Access Compliance Report

Public Rights-of-Way

(Pedestrian Signals)

Intersection ID: N/A	Main Street:	Cross Street: N/A	Location: N/A
ADA ID: 9BB62000FED6	Signal Type: One Push Button-Non APS	Overall Compliance: No	Severity Score: BTN 1: N/A BTN 2: N/A No BTN: N/A
Codes/Mitigation Info/Possible Solution		Field Measurements/Component Compliance

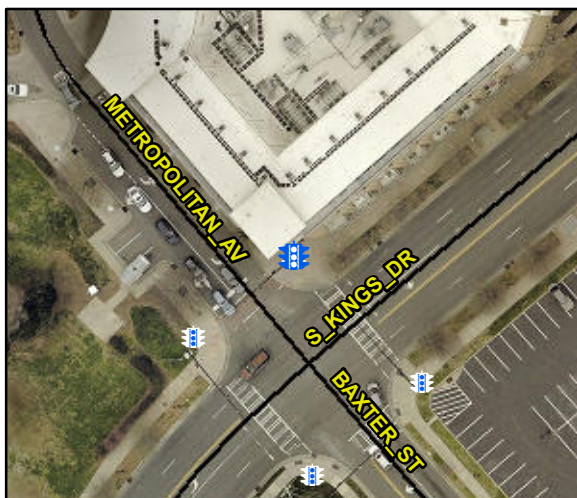
Yes	B 1 Clear Xing Direction?	ClearlyMarked	N/A	B 2 Clear Xing Direction?	N/A
	B 1 Crossing Direction	To SE		B 2 Crossing Direction	N/A
Yes	B 1 DistanceTo XWalk (in)	0.0	N/A	B 2 DistanceTo XWalk (in)	N/A
No	B 1 DistanceTo Curb (in)	206.0	N/A	B 2 DistanceTo Curb (in)	N/A
Yes	B 1 Diameter (in)	2.0	N/A	B 2 Diameter (in)	N/A

Possible Solutions: Replace Signal Push Button With APS Button on New Post. Remove & Relocate Sign.

PROW/ADA: TMUTCD 4e.08, R406.2
